B I D A D D E N D U M 0 5

The items set forth herein, whether of omission, addition, substitution, or clarification are to be included in and form a part of the construction documents for the project listed above.

ORANGE-ULSTER BOCES
AXELROD - MAIN
BUILDING
ADDITIONS +
ALTERATIONS
53 GIBSON ROAD
GOSHEN, NY 10924

S301

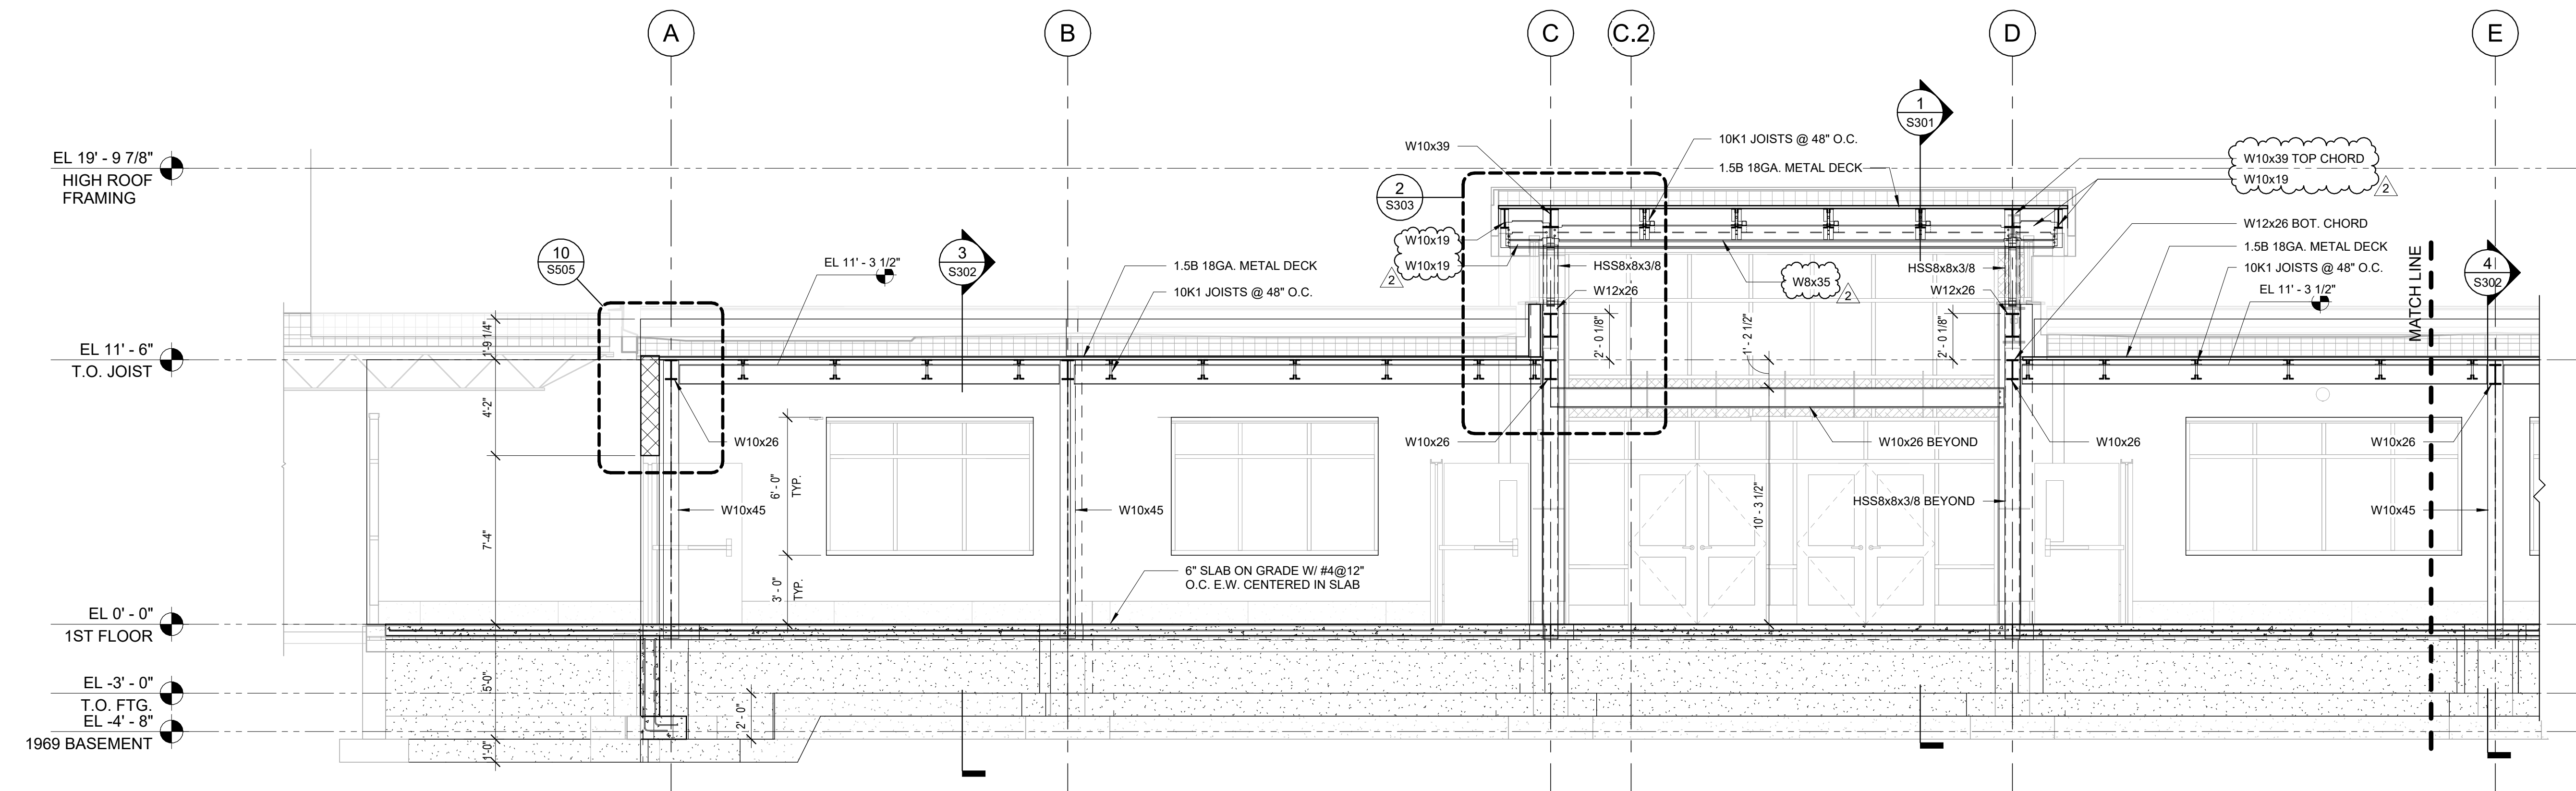
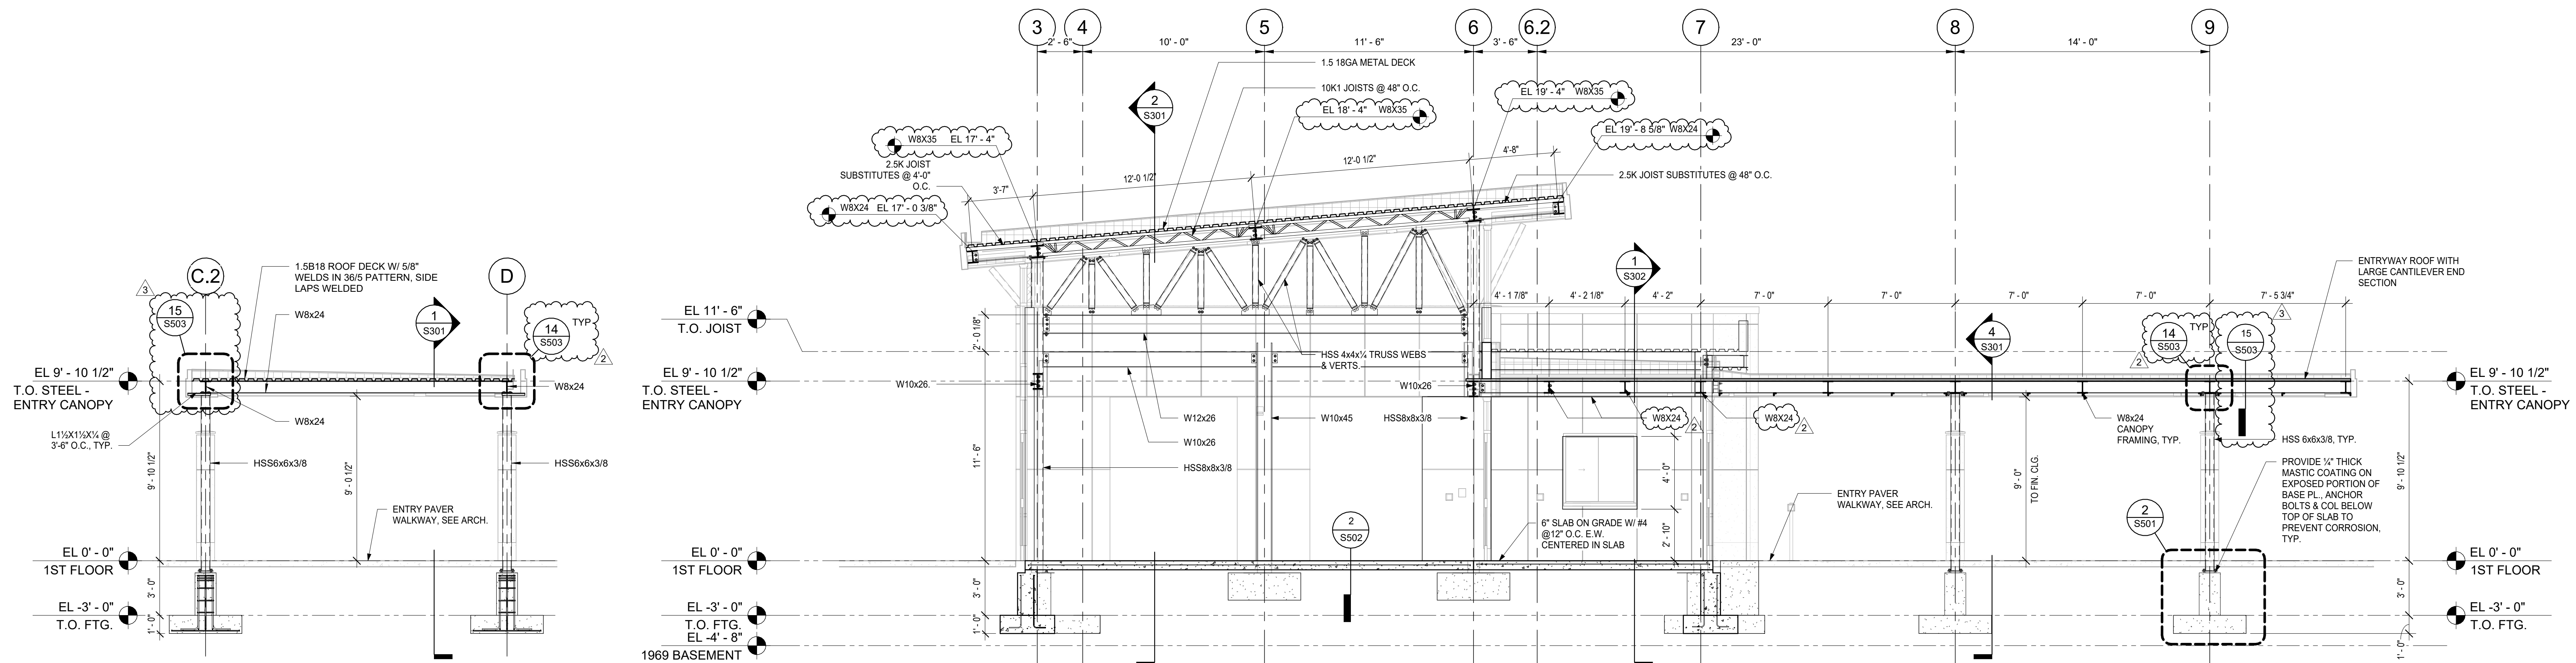
- 5.1 S301 Building Sections and S503 Structural Steel Connection Details
 - a. Attached please find the following revised Structural Drawings with additional framing information at the main entrance canopy.
See revisions to details 4/S301 and 15/S503.
Note: Detail 15/S503 shall be typical for both sides of canopy along grid lines ‘C.2’ and ‘D’

A101

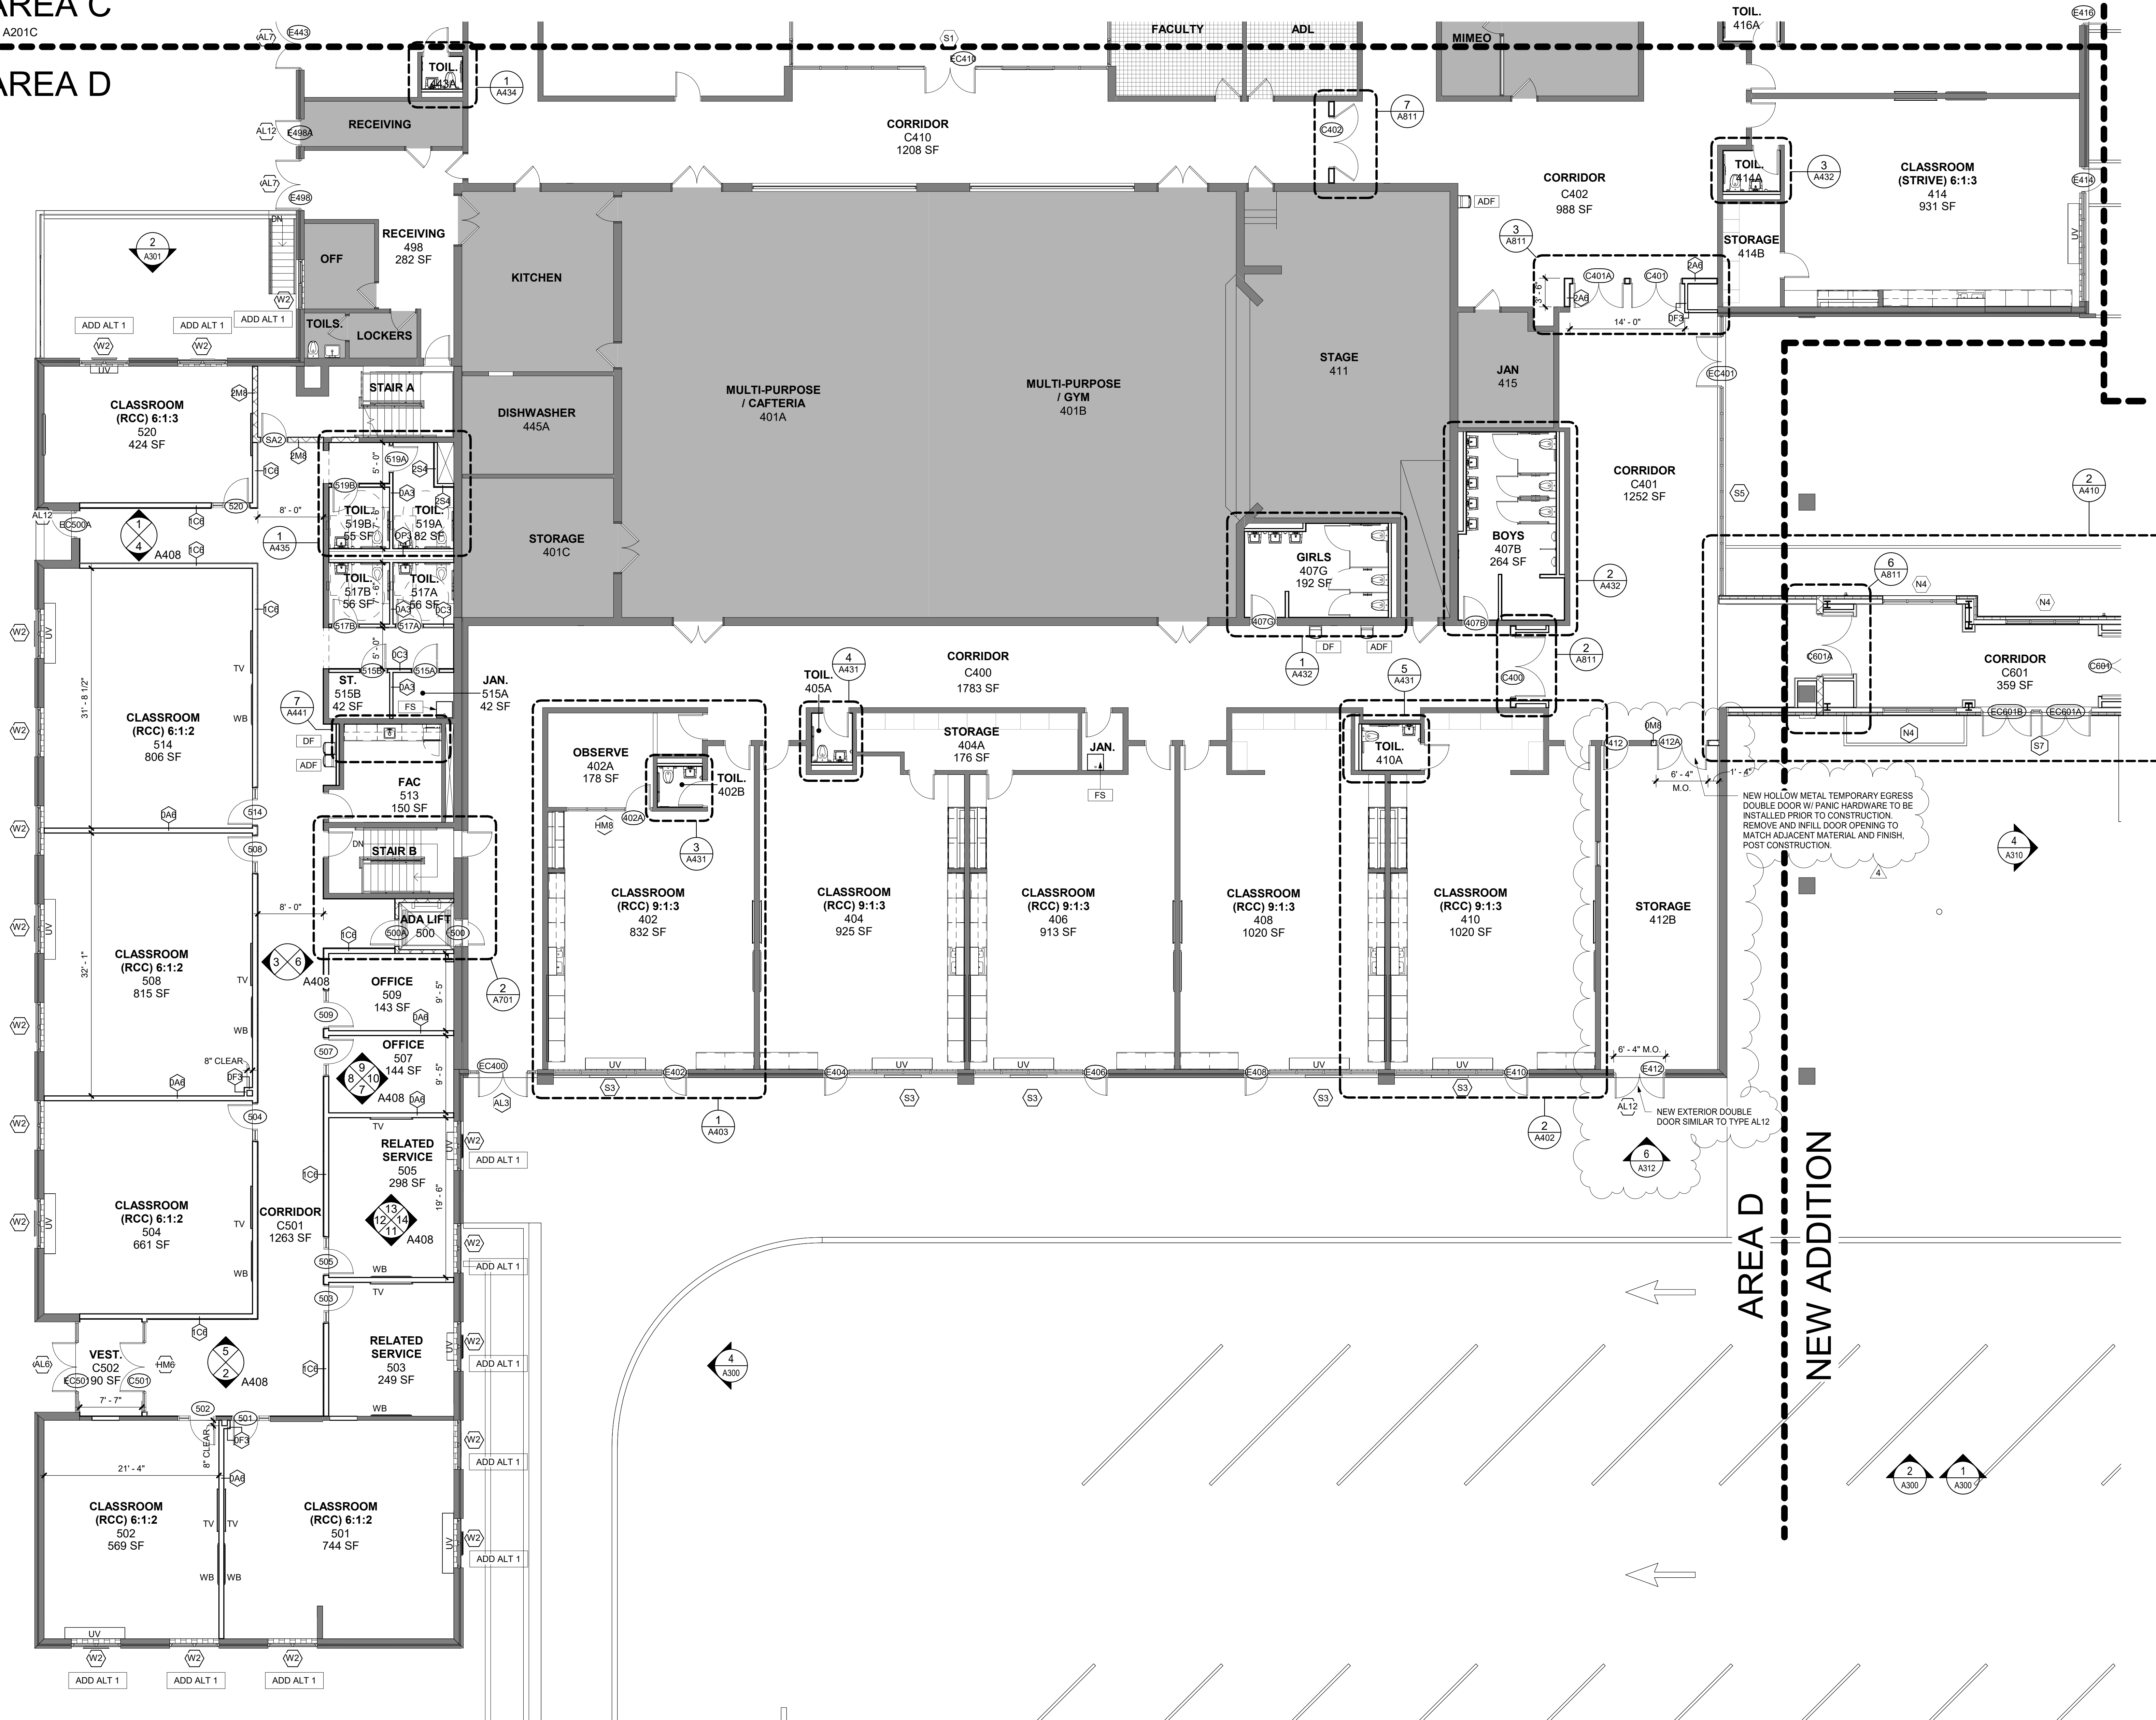
- 4.1 A101 Overall First Floor Demolition Plan
 - a. See REVISED A101 with additional information on demolition of the existing canopy at the existing main entrance, and information on demolition in the area of Office 412 for temporary egress during construction.
- 4.2 A201D First Floor Plan Part D
 - a. See REVISED A201D with information on Storage 412B and double doors required for egress during construction.
- 4.3 A312 Building Sections
 - a. See REVISED A312 with additional information on modifications to the existing building at the area of the existing main entrance required after demolition, and elevation of double door at Storage 412B for egress.

P101B

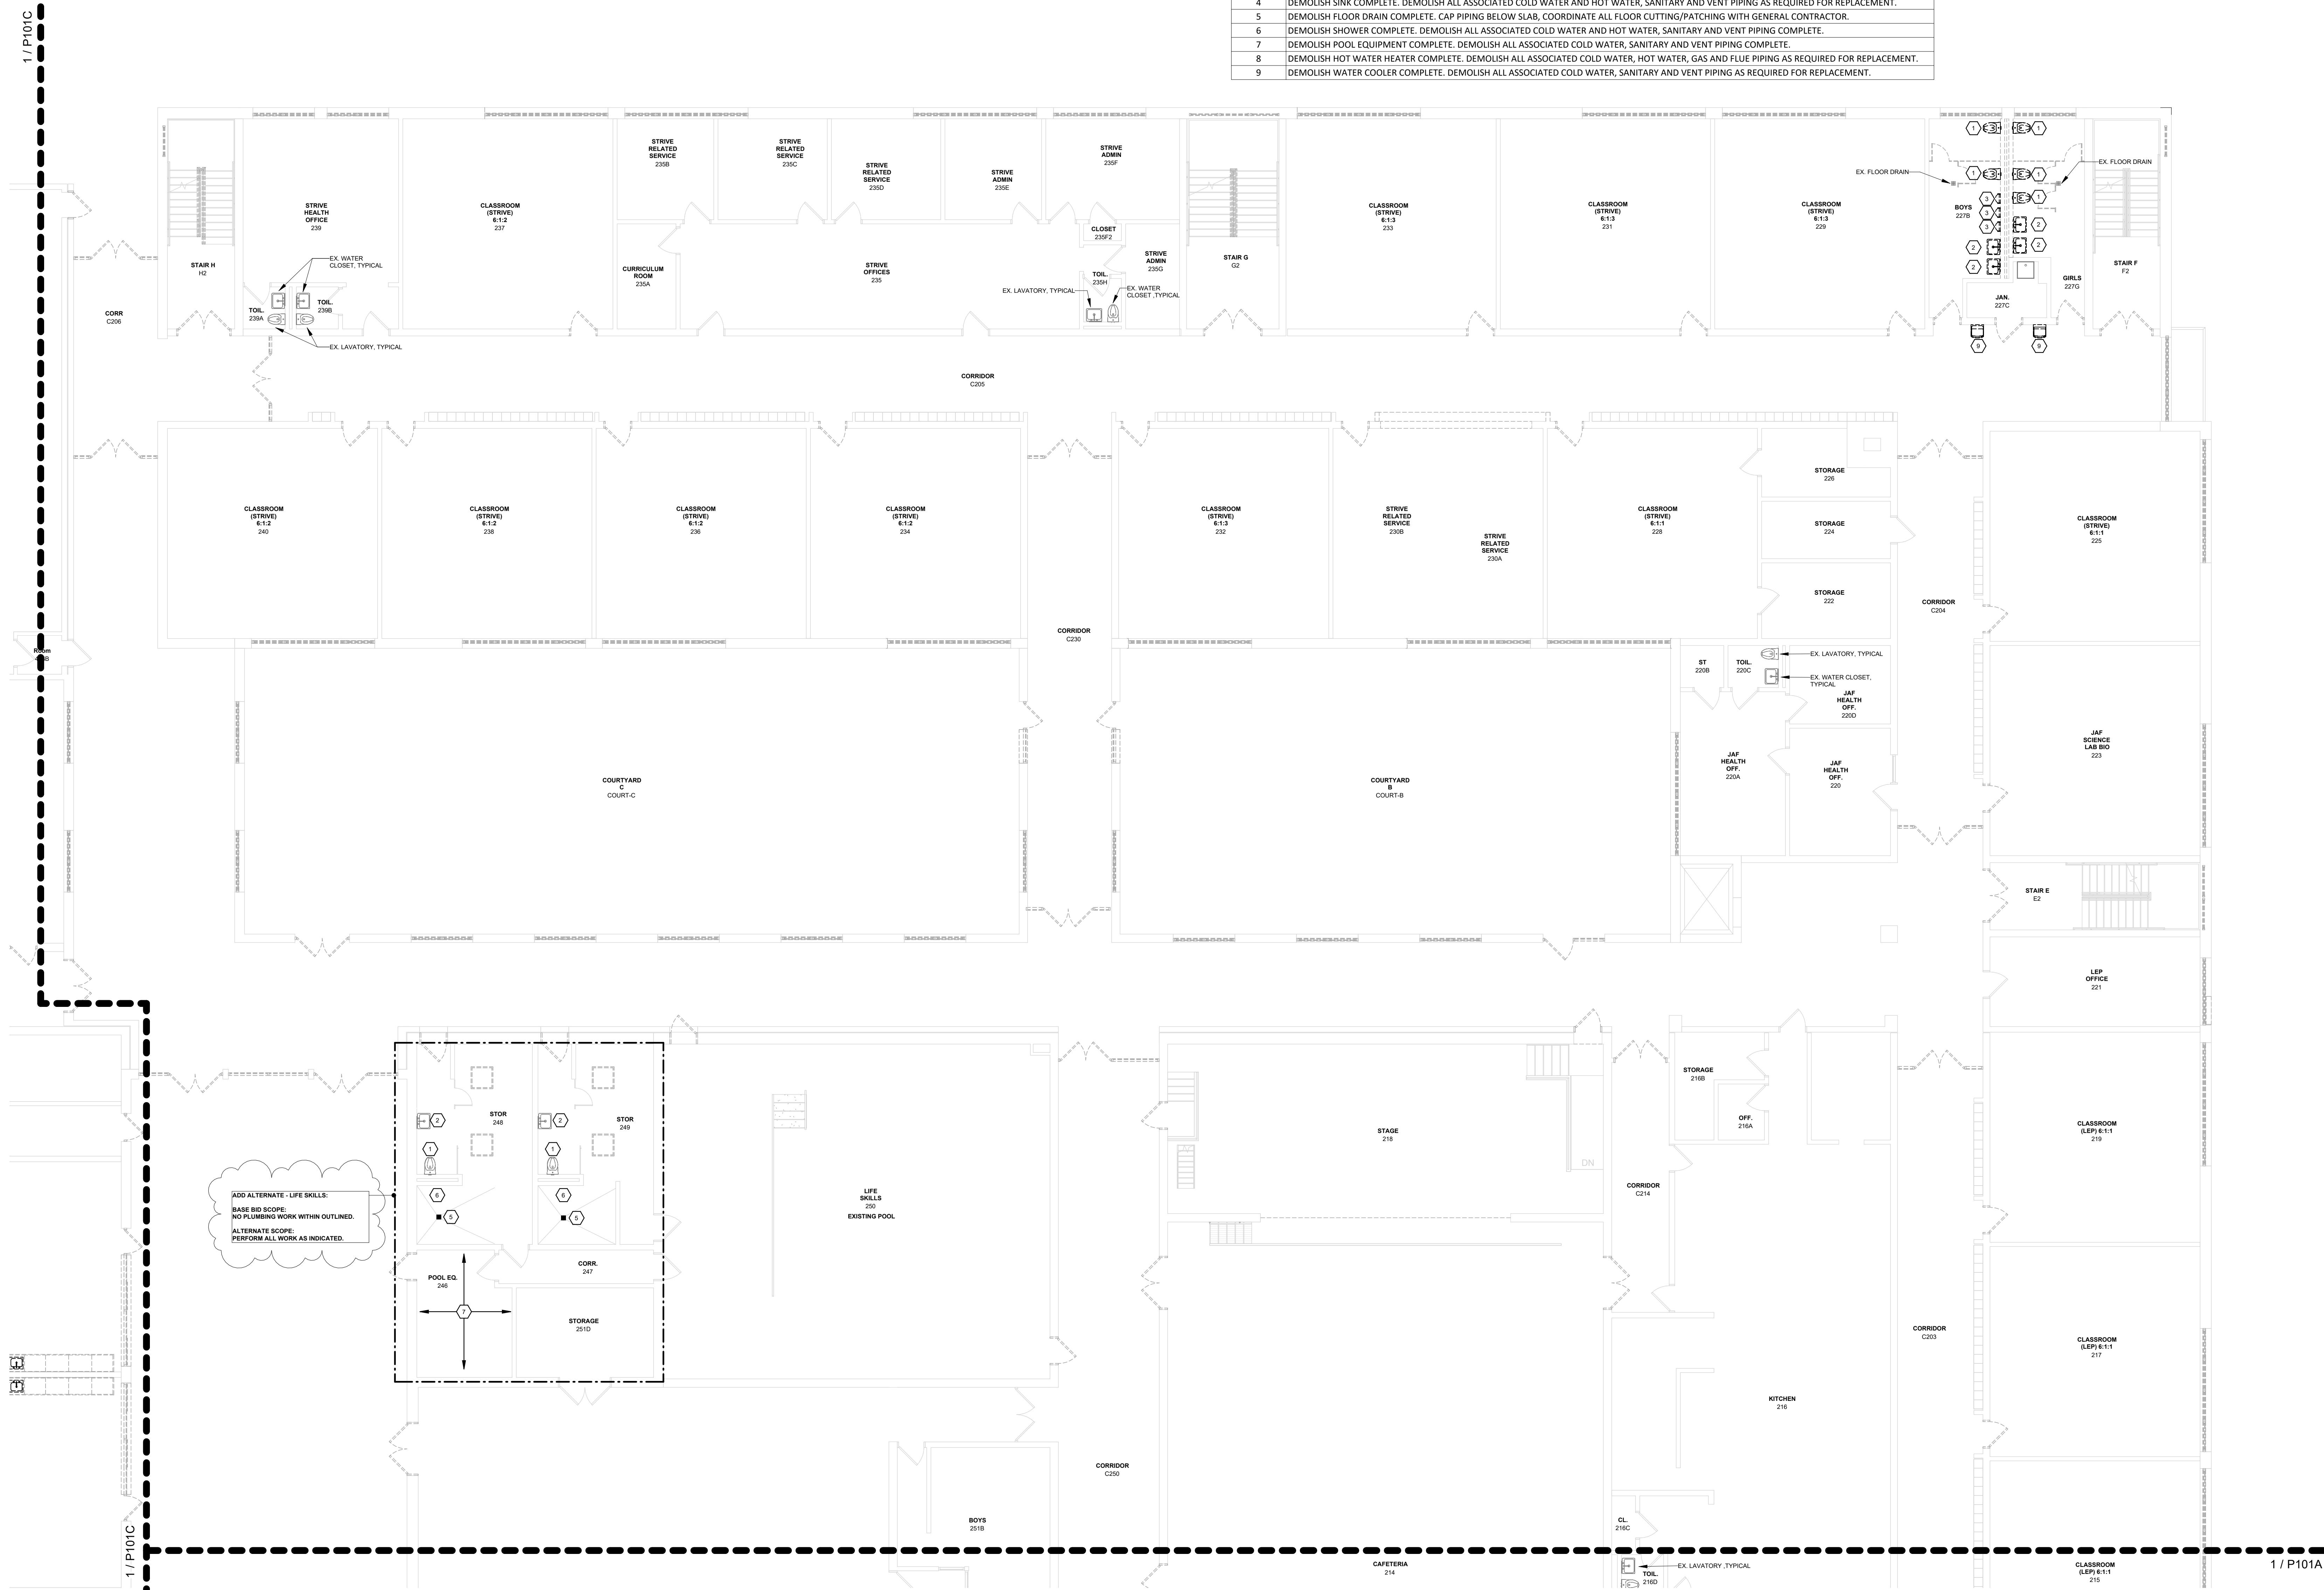
- a. Drawing P101B – Plumbing First Floor Demo Plan Part B
- 6.8 Attached please find the following revised Mechanical Drawings with modifications and/or additional information clouded:
